Application Number: 21/01288/FUL

Description: Two-storey side and rear single storey extension (part-retrospective, re-submission of 21/00604/FUL)

At: 38 Coberley Close, Downhead Park, Milton Keynes, MK15 9BJ

Proposed Elevations

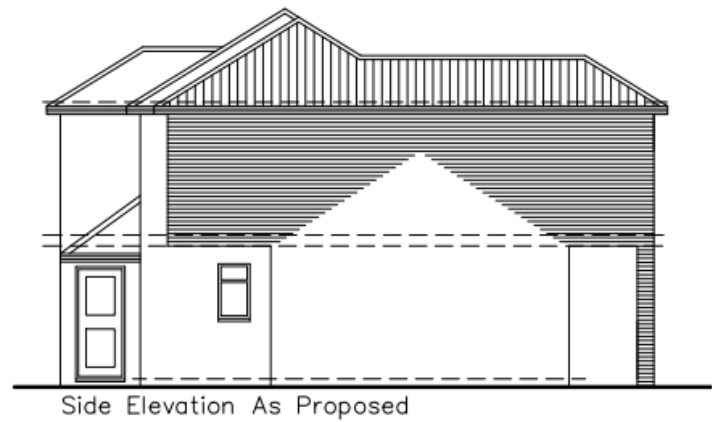
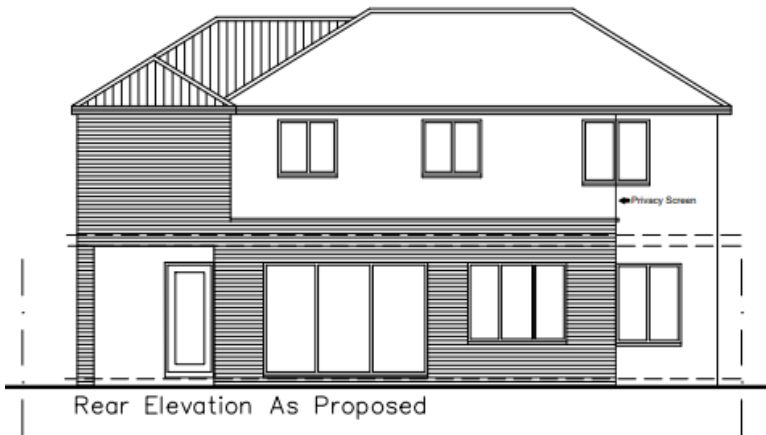
A question was raised with MKC planning case officer re plans inaccuracy which was not welcomed by the applicant as he feels that he has made amendments to the build at the request of GLPC. The elevations for side and front do not match with the ground floor plan.

Condition: The Front elevation is cantilevered, and the ground floor front does not increase (not indicated on plans submitted)

- 7.17 The condition requested by Great Linford Parish Council to retain the cantilevered front elevation, in order to retain parking, is not necessary, as any permission would be granted in accordance with the approved plans only. Such a condition would be unreasonable and unnecessary in this regard. Any future works forward of a wall forming part of the front elevation would require express planning permission and would be assessed under a planning application.

Privacy Screen

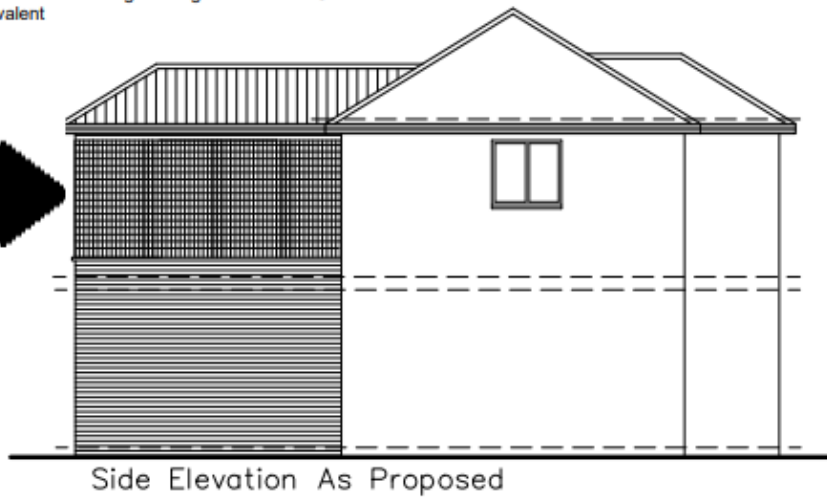
- 7.5 The proposed obscure-glazed privacy screen has been included as a response to the privacy concerns which resulted in the refusal of the most recent application (ref. 21/00604/FUL). A similar privacy screen was proposed under the first application (ref. 20/02598/FUL), though this differed from the current application as it also proposed a roof terrace above the single storey rear extension, which is not included

on the current proposed plans. The proposed screen would be visible from the rear garden of No.4 Brockhampton but would not be visible from the street. It is considered that the visual impact of the screen would be minimal, and it would not detract significantly from appearance or character of the dwelling or surrounding area, and the visual impact of this screen was not a focus of the reason for refusal under the first application.

The applicant has resubmitted original plans with a privacy screen of 1.8.

Condition: That the Juliet balcony remains in place with privacy screen

3. The privacy screen as shown on the approved plans shall be constructed and implemented in accordance with these details prior to the first occupation of the first-floor bedroom served by the Juliet balcony, and thereafter be retained in accordance with the specifications set out on drawing no. 2020/0080/0001 Rev D.
